Pentium[®] Processor for Embedded Applications

Specification Update

December 1998

Order Number: 273183-002

68. Asserting TRST# Pin or Issuing JTAG Instructions Does not Exit TAP Hi-Z State

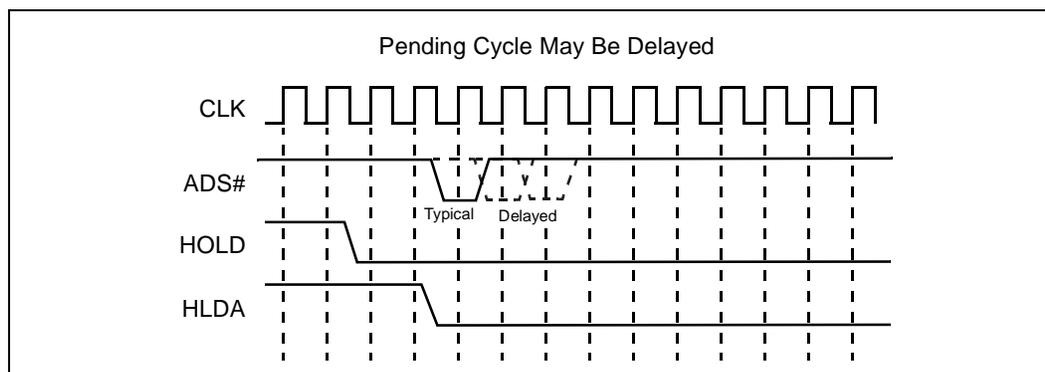
Problem: The Pentium® Processor Family Developer's Manual, Section 11.3.2.1 states that the TAP Hi-Z state can be terminated by resetting the TAP with the TRST# pin, by issuing another TAP instruction, or by entering the Test_Logic_Reset state. However, the indication that the processor has entered the TAP Hi-Z state is maintained until the next RESET. Therefore by using the above methods alone, the TAP Hi-Z state can not be terminated.

Implication: When the TAP Hi-Z instruction is enabled and executed, the processor may not terminate the Hi-Z state.

Workaround: To exit TAP Hi-Z state, in addition to the methods described above, the processor needs to be RESET as well.

69. ADS# May be Delayed After HLDA Deassertion

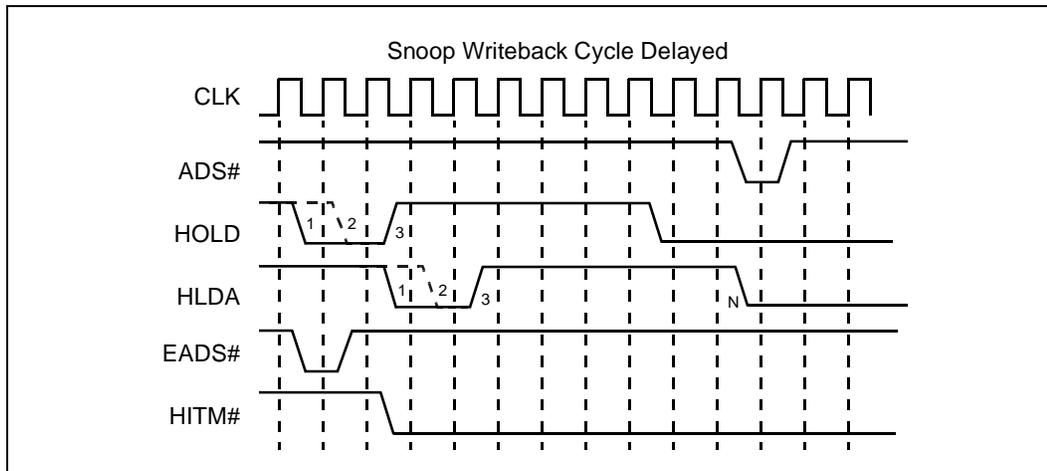
Problem: The Pentium processor typically starts a pending bus cycle on the same clock that HLDA is deasserted and the Pentium processor with MMX technology typically starts the cycle one clock after HLDA is deasserted. However, in both processors it may be delayed by as many as two clocks. See the diagram below:

In two cases, for example, if HOLD is deasserted for one clock (i.e., clock 2) or two clocks (i.e., clocks 1 & 2) and then reasserted, the window may not be large enough to start a pending snoop writeback cycle. The writeback cycle may be delayed until the HLDA is deasserted again (i.e., clock N). See diagram below.

Implication: If the system expects a cycle, for example a writeback cycle, and depends on this cycle to commence within the HLDA deassertion window, then the system may not complete the handshake and cause a hang.

1. Deassert HOLD for at least 3 clocks (i.e., clocks 1, 2, and 3 shown in figure) before reasserting HOLD again. This ensures that the Pentium processor initiates any pending cycles before reasserting HLDA.
2. If the system is waiting for the snoop writeback cycle to commence, for instance if HITM# is asserted, the system should wait for the ADS# before reasserting HOLD.
